**ADDENDUM NO. 2**

PROJECT TITLE:  
**REPLACEMENT OF  
 BRIDGE NO. 06896, ROUTE 156  
 OVER ARMSTRONG BROOK**

TOWN:  
**OLD LYME**  
 DRAWING TITLE:  
**RIGHT-OF-WAY  
 PLAN**

PROJECT NO.  
**104-175**  
 DRAWING NO.  
**ROW-1**  
 SHEET NO.  
**03.02.A2**

PROJECT NO.  
**104-175**  
DRAWING NO.  
**XSC-02**  
SHEET NO.  
**03.13.A2**

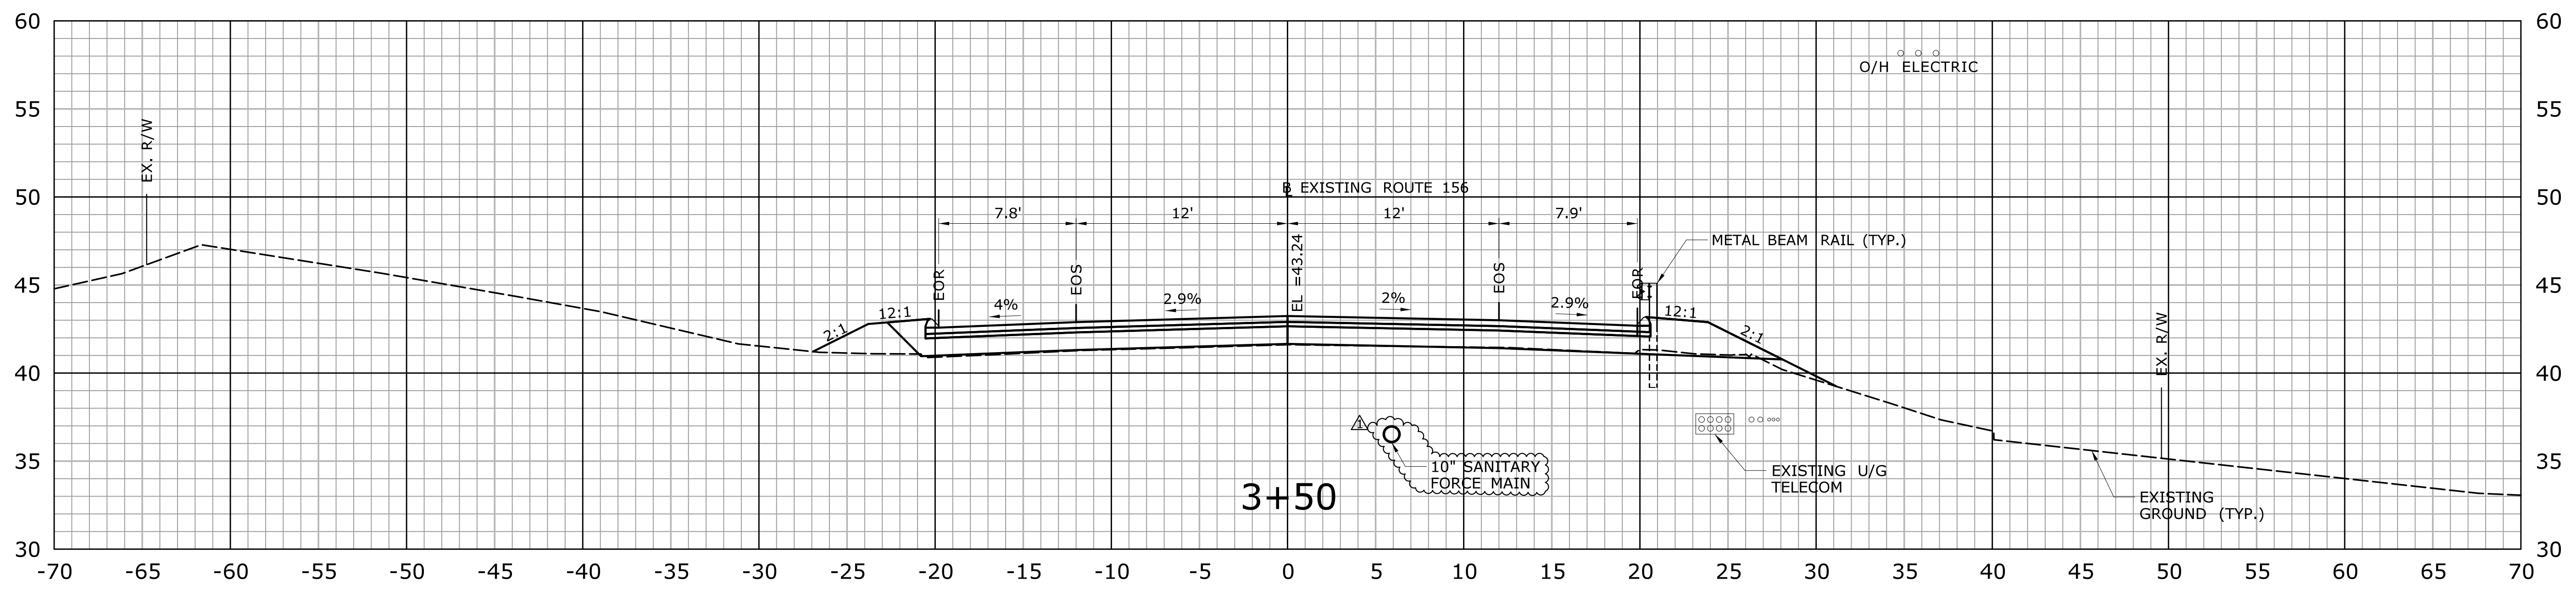
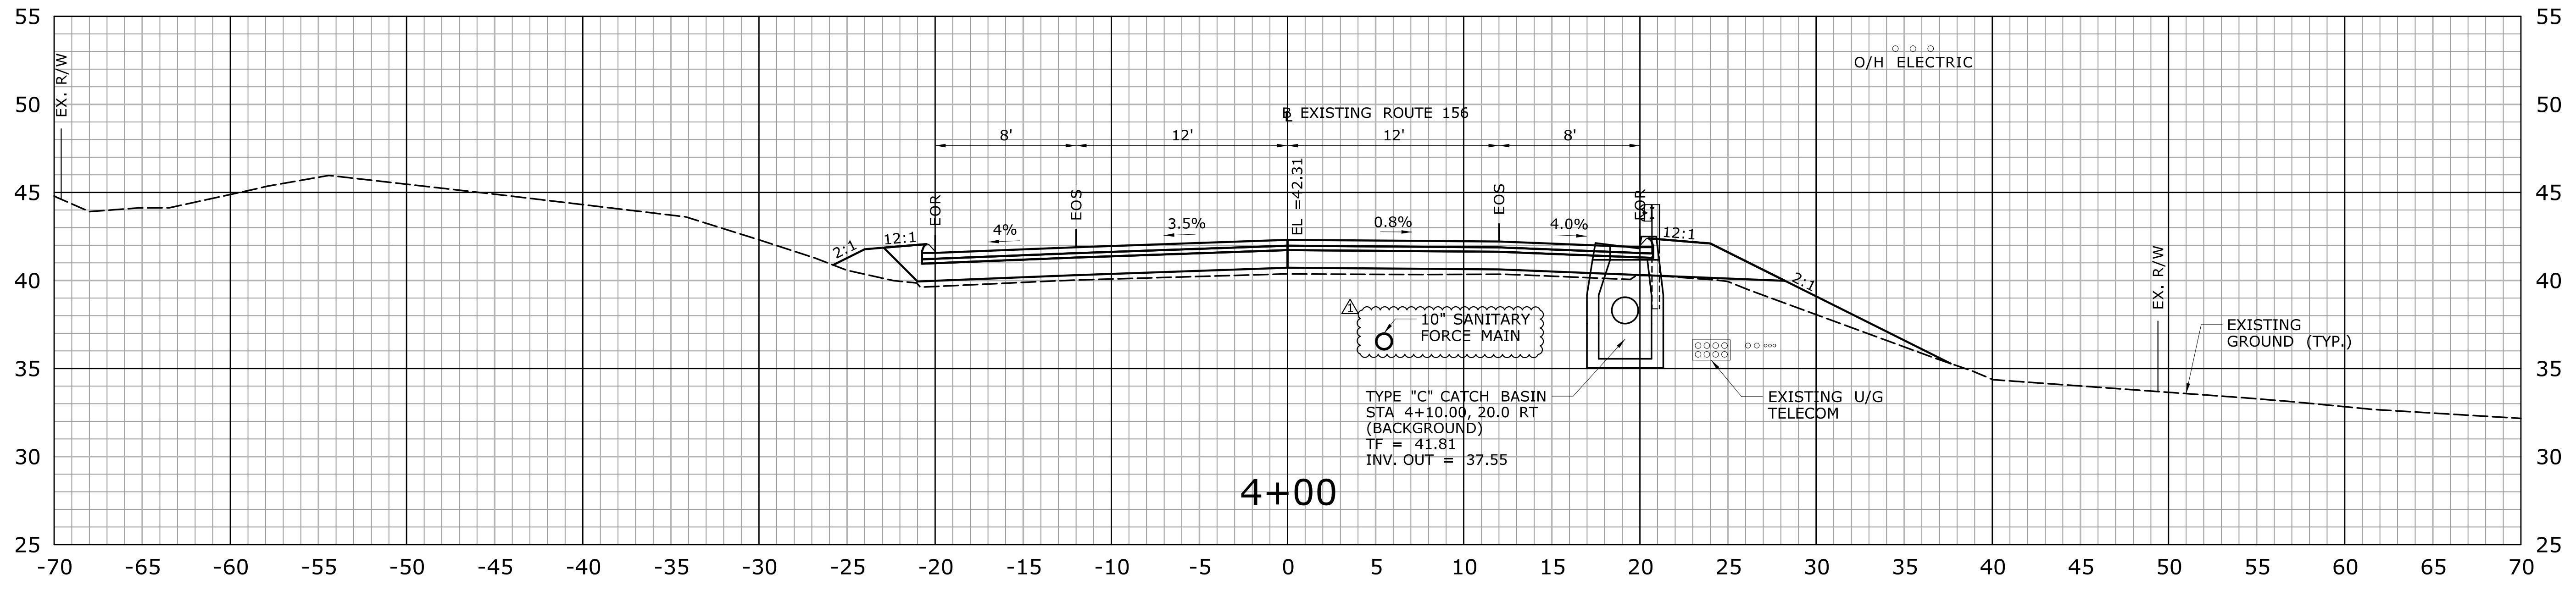
REV.	DATE	REVISION DESCRIPTION	SHEET NO.
1	1.31.25	ADD SANITARY FORCE MAIN	03.13

PROJECT NO.  
**104-175**  
 DRAWING NO.  
**XSC-03**  
 SHEET NO.  
**03.14.A2**

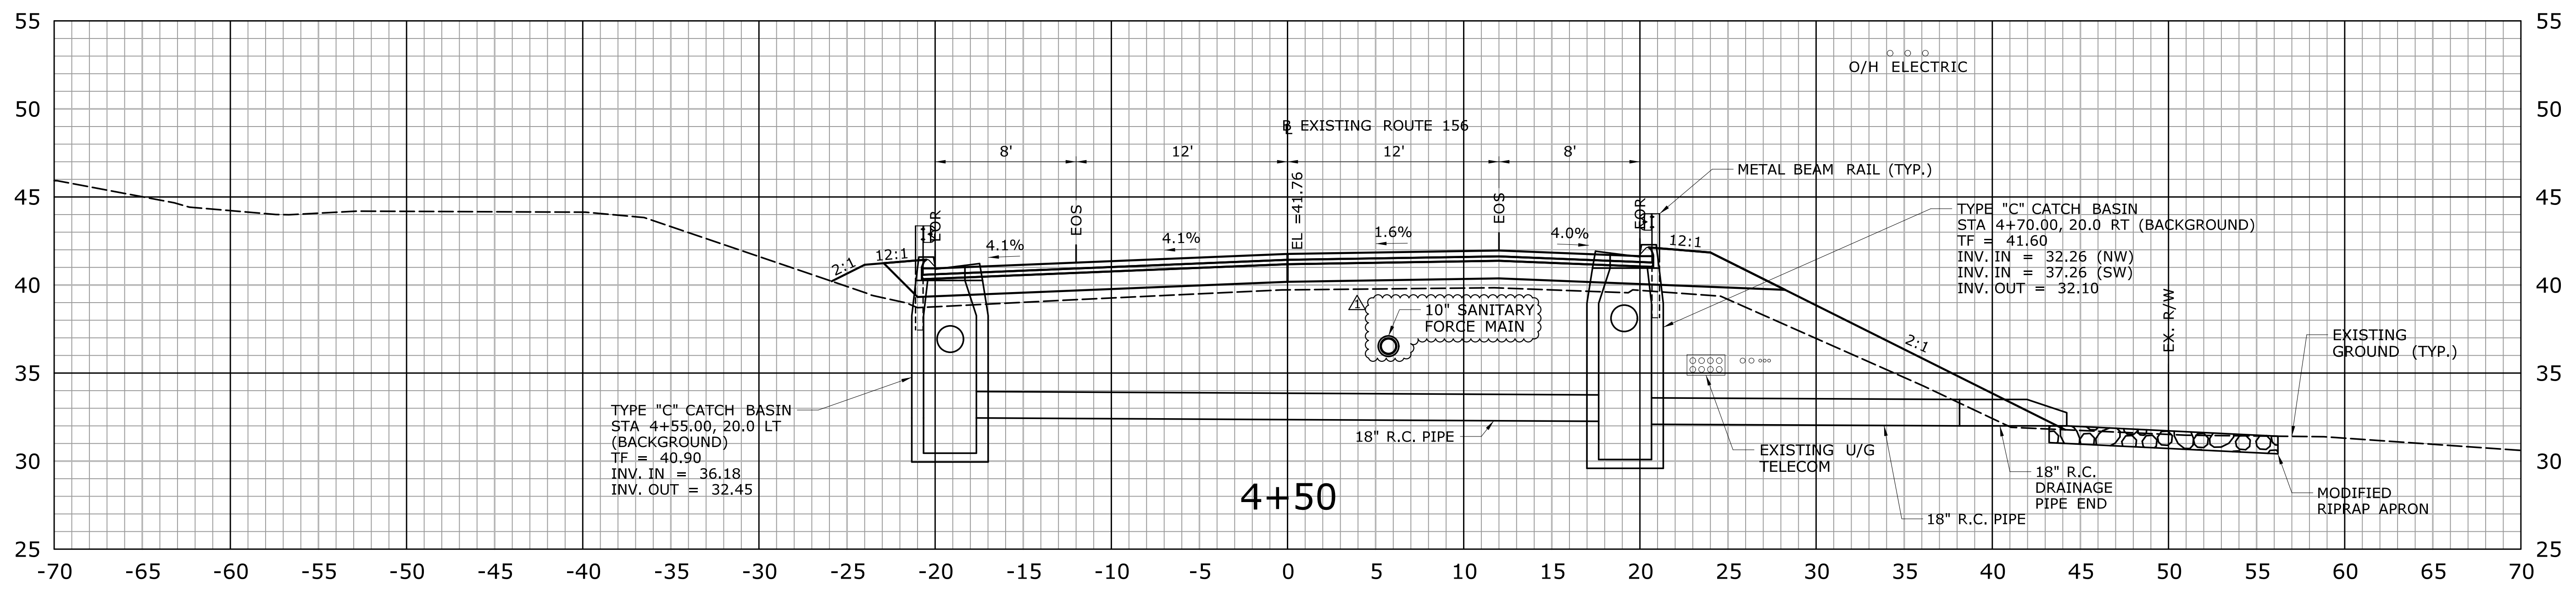
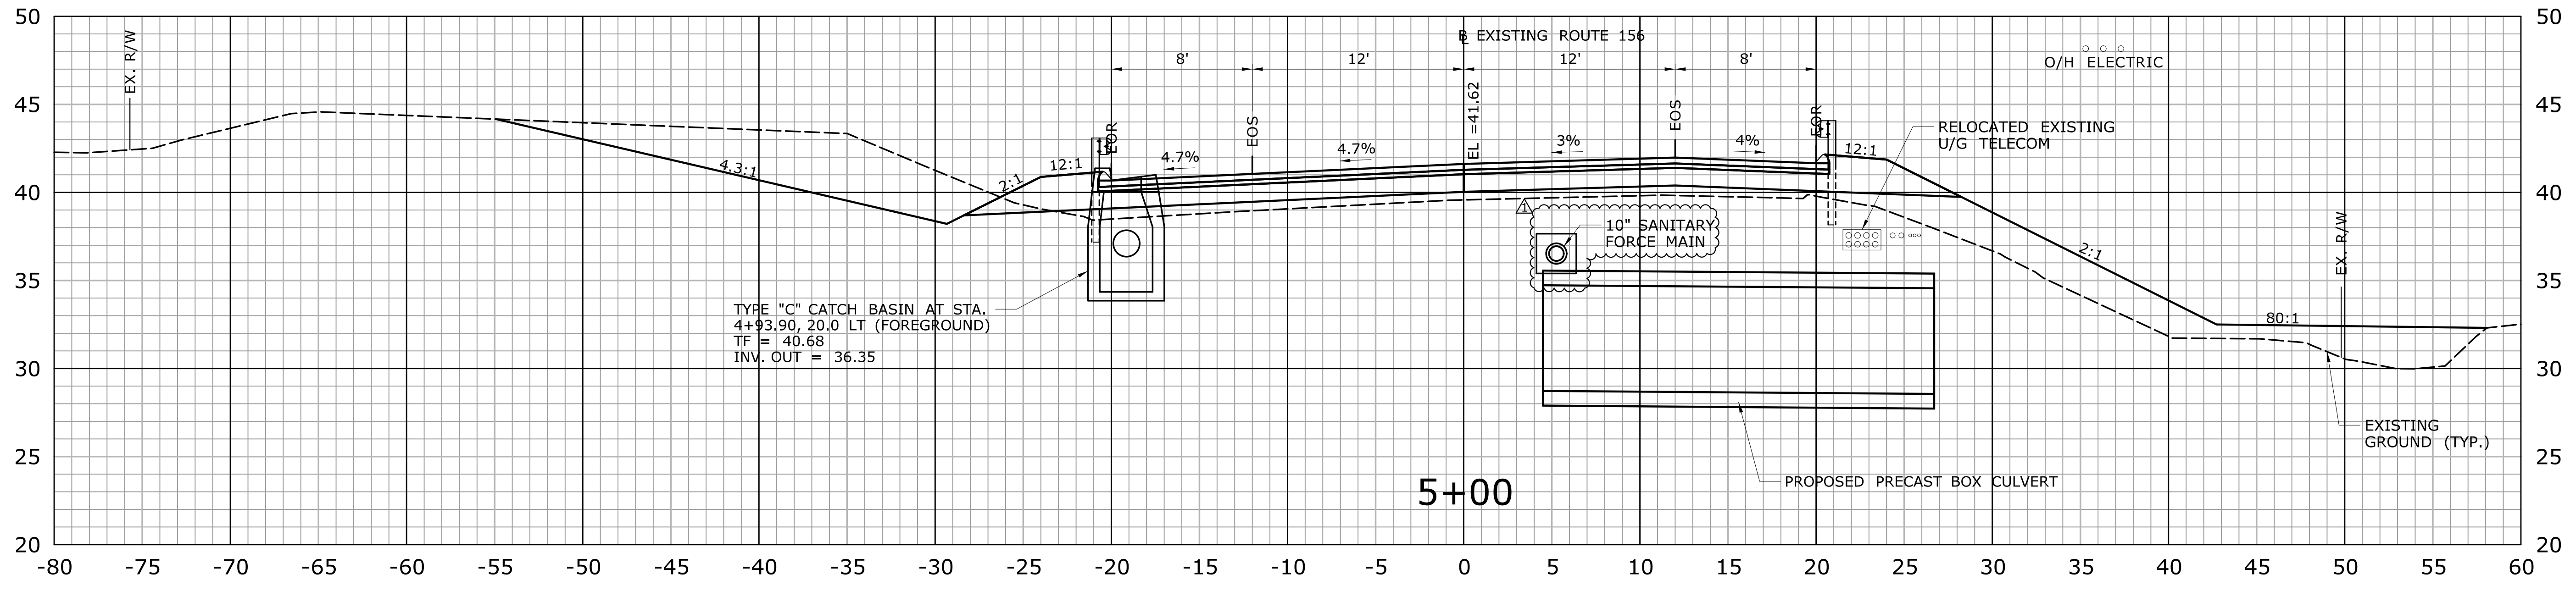
REV.	DATE	REVISION DESCRIPTION	SHEET NO.
1	1.31.25	ADD SANITARY FORCE MAIN	03.14

SHEET NO.  
**03.15.A2**

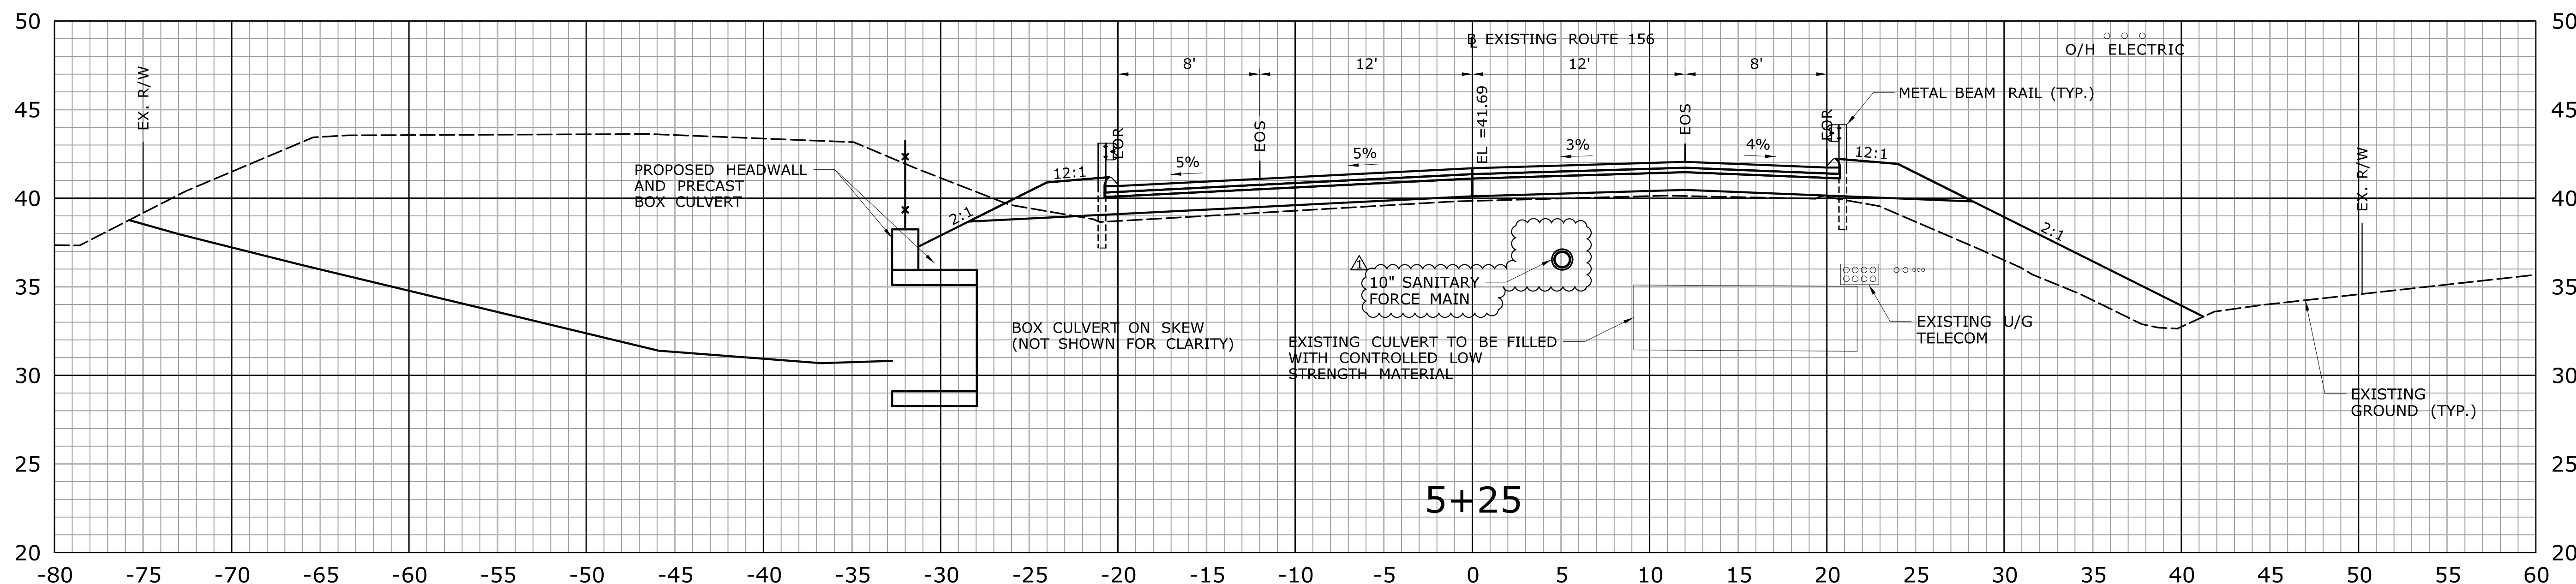
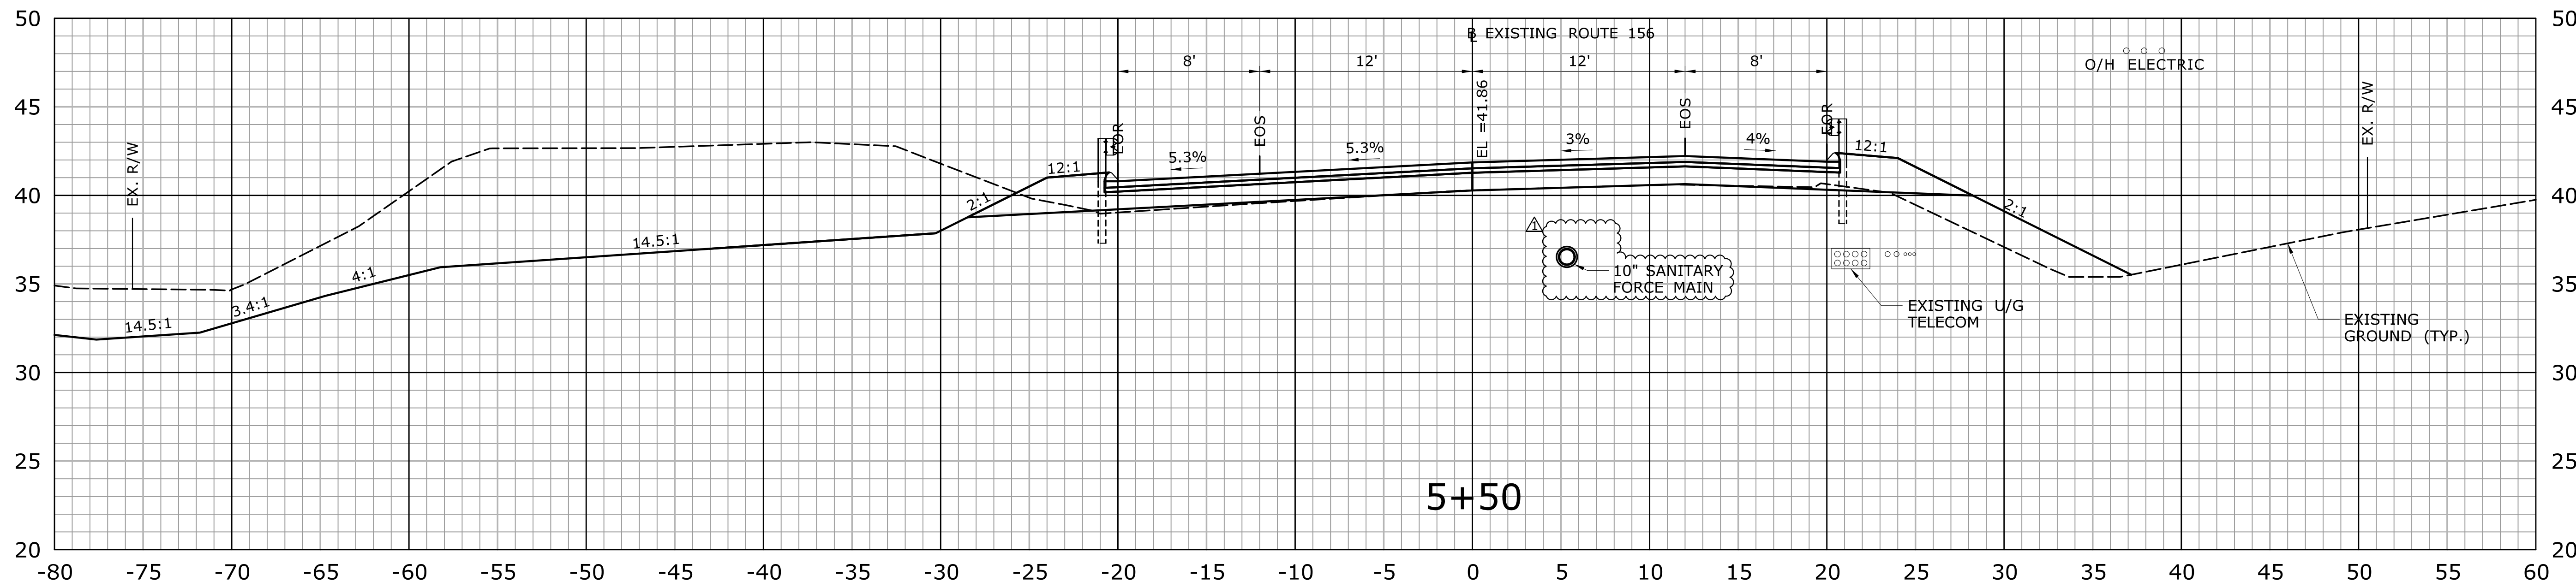
REV.	DATE	REVISION DESCRIPTION	SHEET NO.
1	1.31.25	ADD SANITARY FORCE MAIN	03.15
